CHANGE ORDER NO. 11

PROJECT: West Sewage Treatment Plant (STP) Improvements  
 OWNER: City of Crest Hill, Illinois  
 CONTRACT: 1-2022  
 CONTRACTOR: Vissering Construction Company

Cost Proposal Request  
West Sewage Treatment Plant Improvements  
City of Crest Hill  
Contract 1-2022  
August 26, 2025

**SHEET**  
174  
E70-ASM1.01

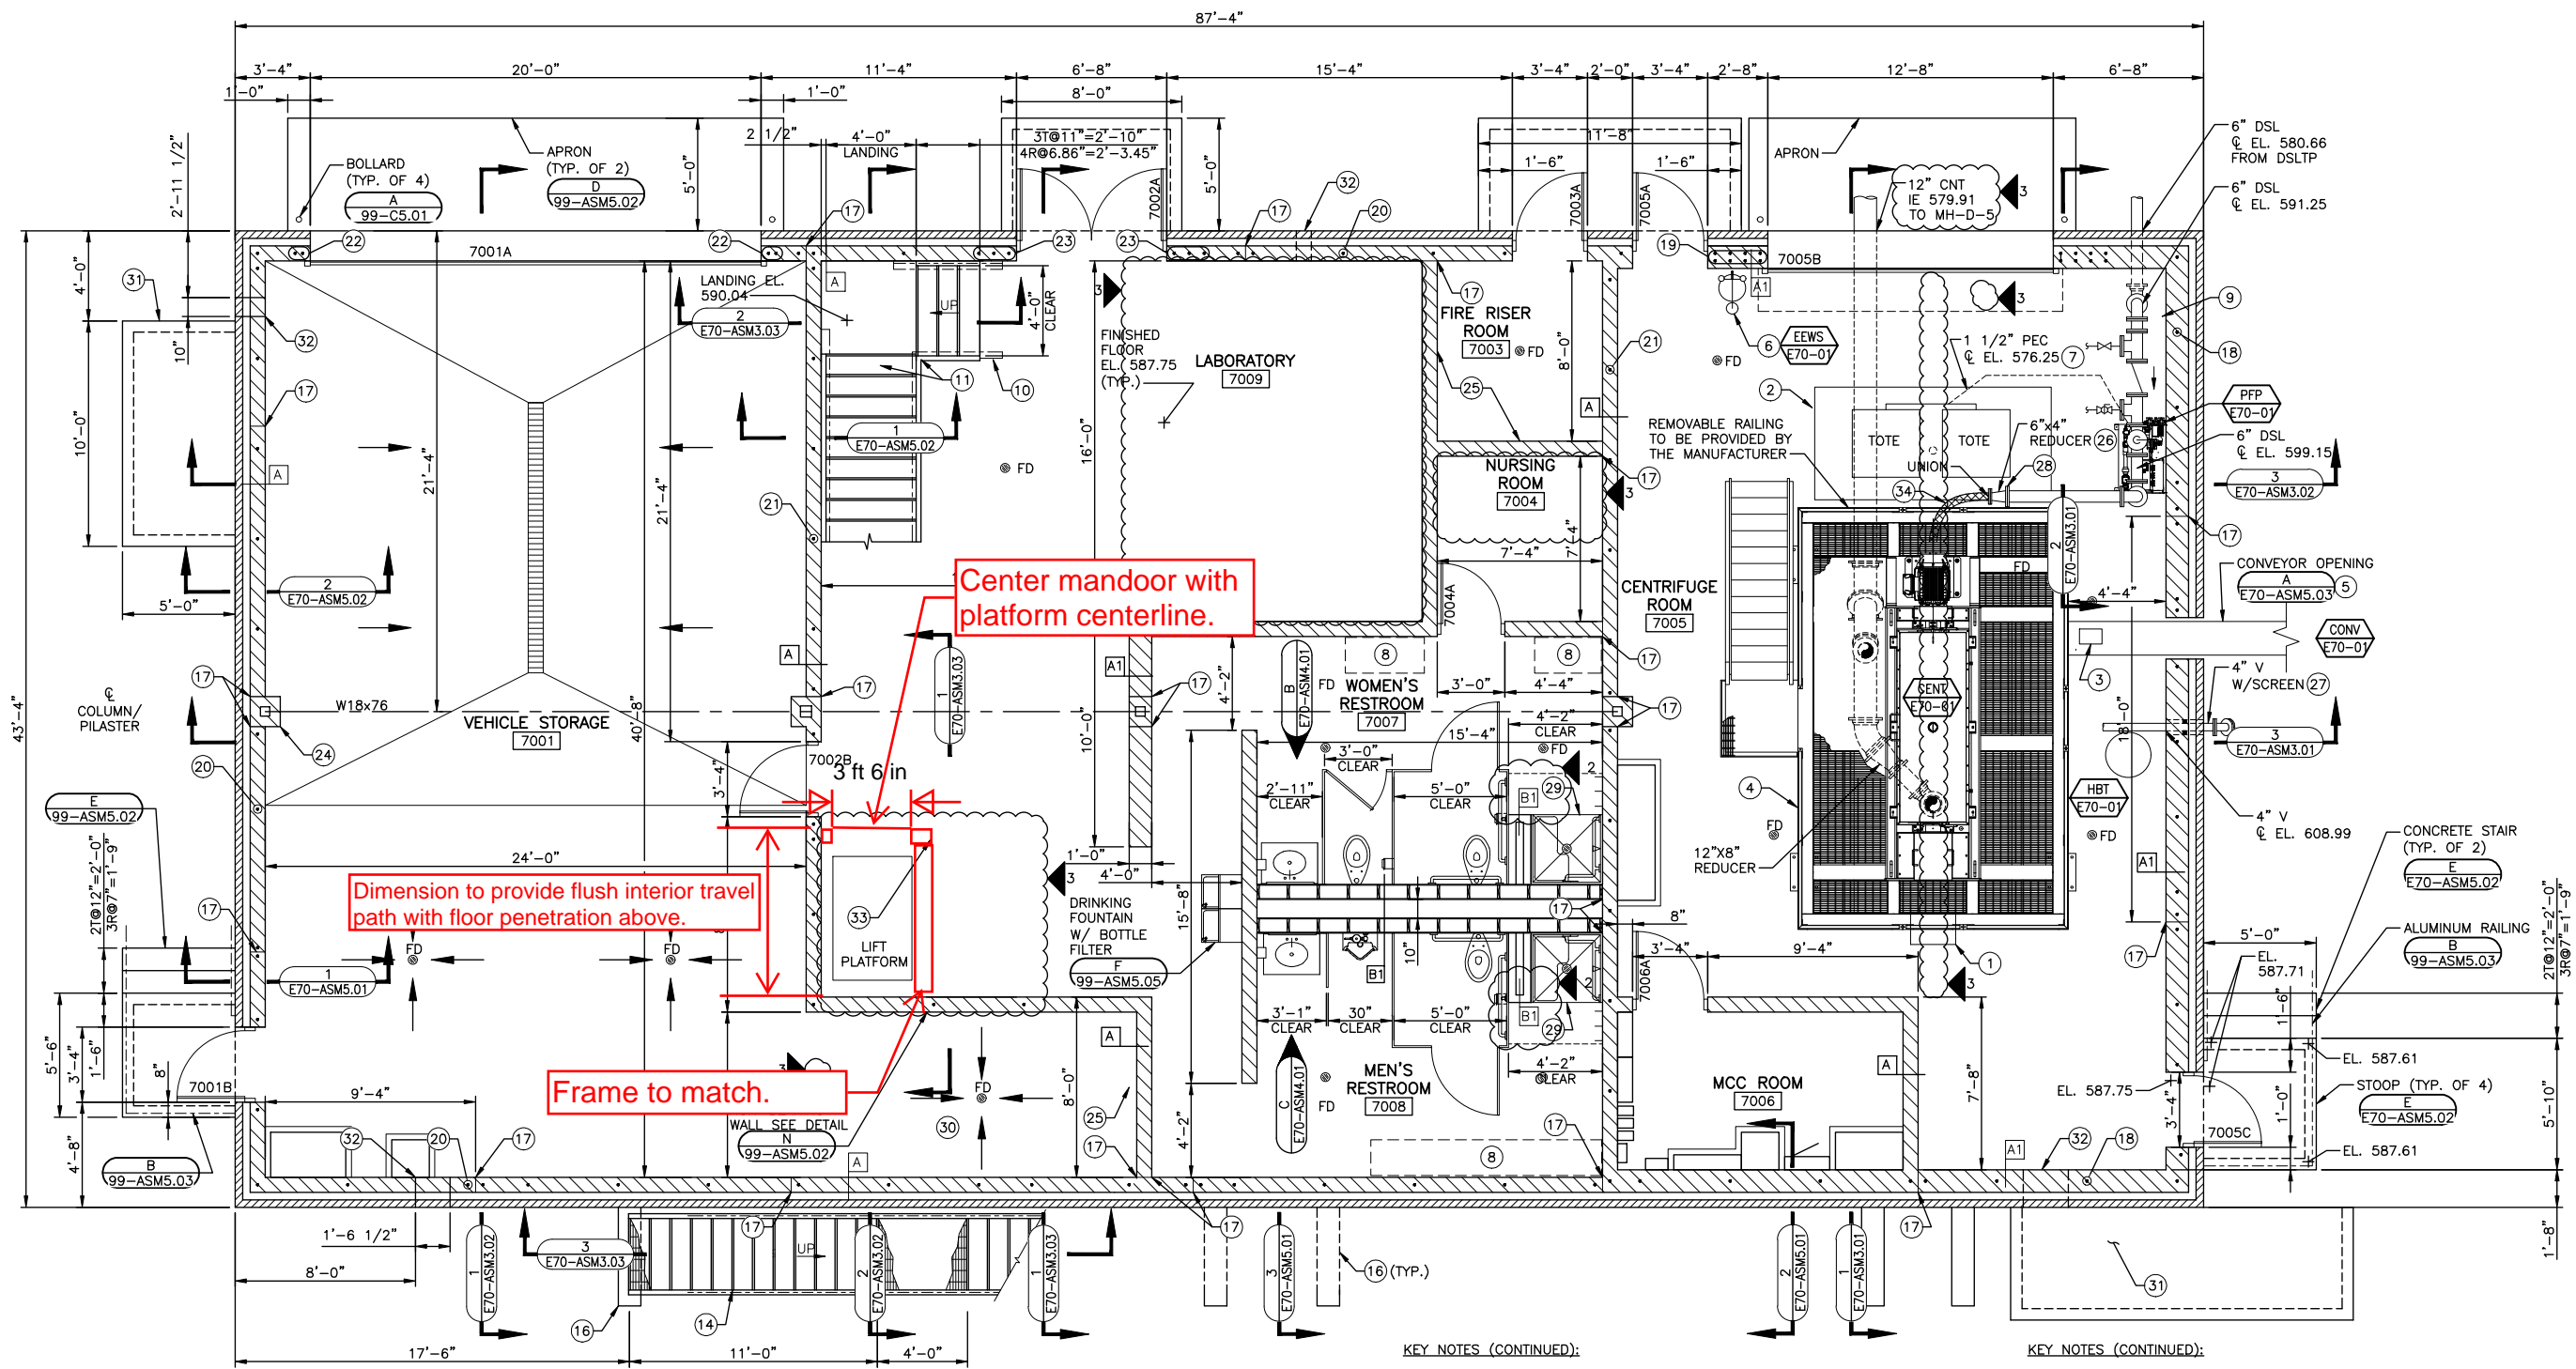
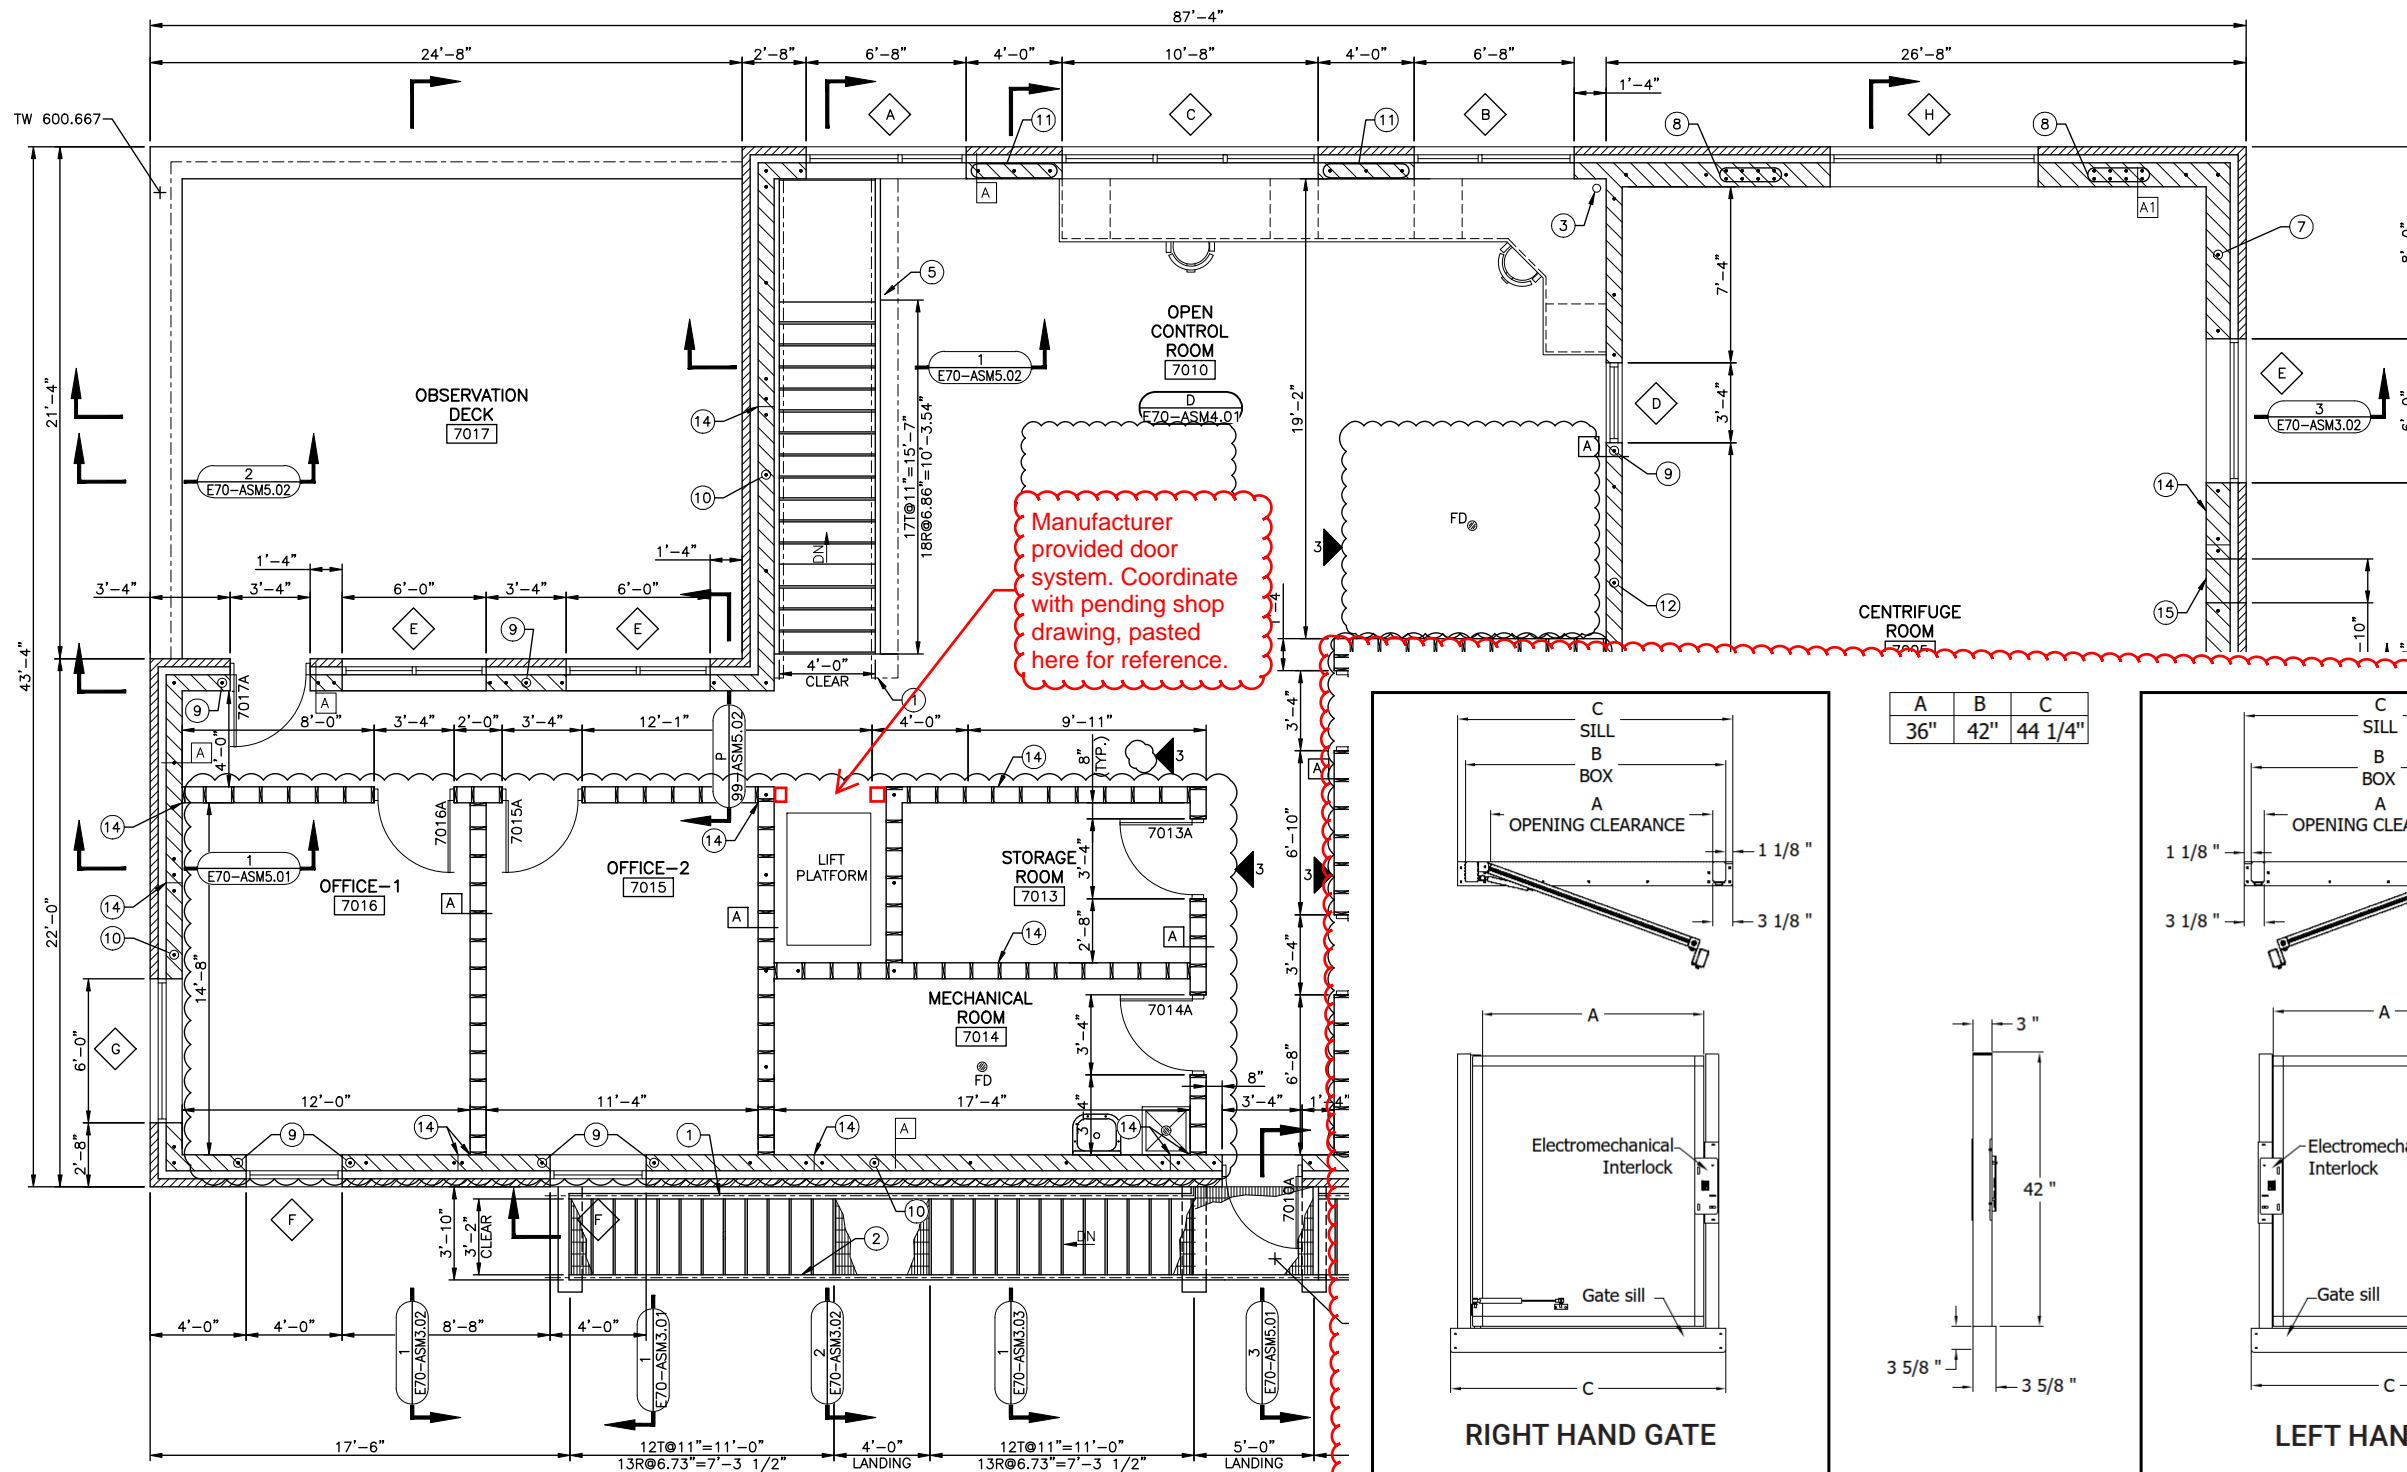
**Drawing E70-ASM1.01**

- 044-01 Frame and drywall the northern and eastern shaft fenestration surrounding the newly proposed door on the first floor. See attached drawing.
- 044-02 Change manufacturer provided first-floor half-height door with full height mandoor. Rewire electrical componentry from manufacturer-provided call-station to interlock doorway hardware (automatic door opener) with platform lift system operation, as described below.

Add row to Drawing 99-ASM6.01 Door 7002C, size 3'-6" x 7'-0", type - STL, active - HG, swing - RHR, frame type - 1, frame material - STL, hardware group - as provided by product manufacturer, active, lintel - B-1, Details, head - F-99-ASM6.02, jamb - F-99-ASM6.02, sill - N/A
- 044-03 Provide attached pictograph (Attachment A) at first floor and second floor call stations. Pictograph shall conform to Section 10 14 00 - Plastic and Metal Signs.

SHEET  
175  
E70-ASM1.02

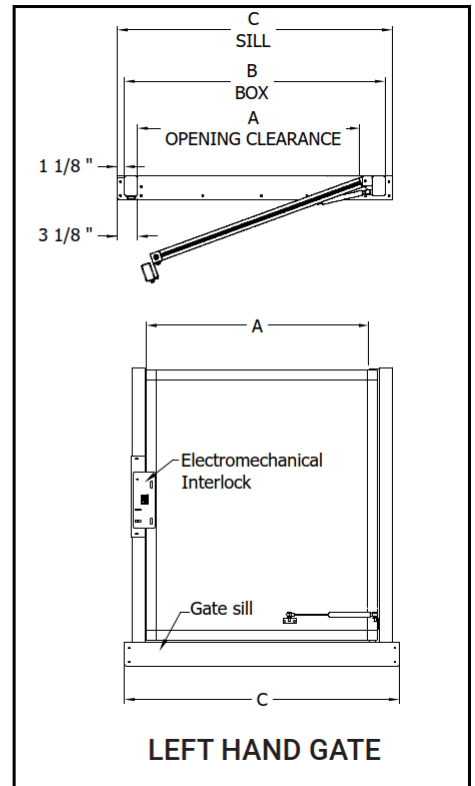
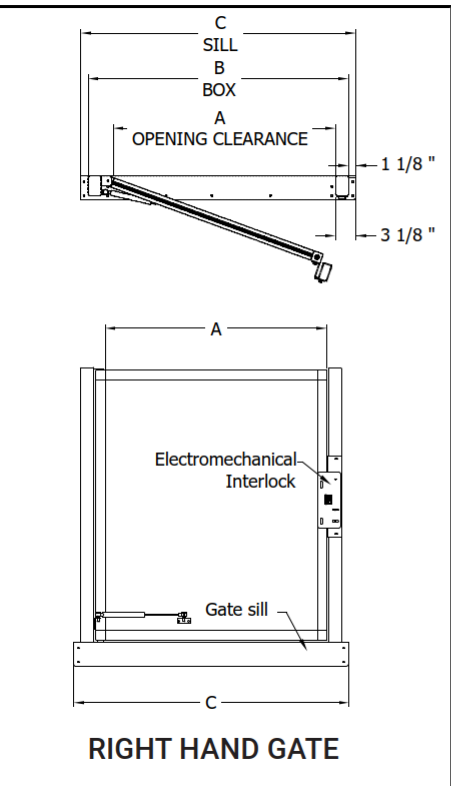
**Drawing E70-ASM1.02**

- 044-04 Frame northern shaft fenestration on second floor. See attached drawing. Standard manufacturer-provided door, its respective wiring, and call-station shall remain at the second floor.
